RE: PORTAGE COUNTY
CITY OF STREETSBORO
STREETSBORO FAMILY HOMES
NPDES PERMIT NO. OHC000003
OHIO EPA PERMIT NO. 3GC05900*AG
CONSTRUCTION STORM WATER

On May 31, 2013, Ohio EPA conducted an audit of the City of Streetsboro and their Municipal Separate Storm Sewer System (MS4) Program. As part of the field review, our audit consisted of a site inspection of the Streetsboro Family Homes project located at Market Square Drive, North of SR 303 between Walters Rd. and Market Square Drive, City of Streetsboro, Portage County. Ohio EPA records indicate that the site is covered by the General National Pollutant Discharge Elimination System (NPDES) Permit for Storm Water Associated with Construction Activity (General Storm Water Permit), permit No. 3GC05900*AG. I was accompanied by Molly Drinkuth of Ohio EPA, Randy Allar of GPD Group, and Amy Flake of the City of Streetsboro during this inspection. While on site, I was able to speak with Ralph Nobis, Superintendent as well as Jayson Porter, Project Manager. The inspection documented the following deficiencies:

Figure 9. The dumpster needs to be covered at the end of each work day or during any rain event.

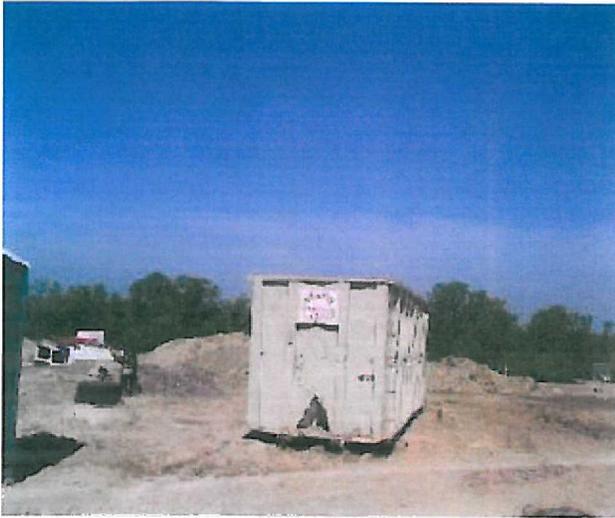
- The inlet protection for the yard drains was inadequate or completely missing (See Figure 8). Inlet protection must be constructed per the detail drawing on the SWP3 including 2"x4" framing, chicken wire mesh, and geotextile fabric for all yard drains. The BMPs must remain intact until all contributing drainage areas have been completely stabilized.
- The dumpster(s) on site do not have a lid or a tarp to prevent their contents from polluting storm water runoff (See Figure 9). Storm water which comes in contact with solid wastes is considered to be a leachate and is not authorized to be discharged under the NPDES Permit issued for this site. If the dumpster company does not offer lidding options for these containers, a tarp must be laid over and tied down to the dumpster at the end of each work day or during any rain event.
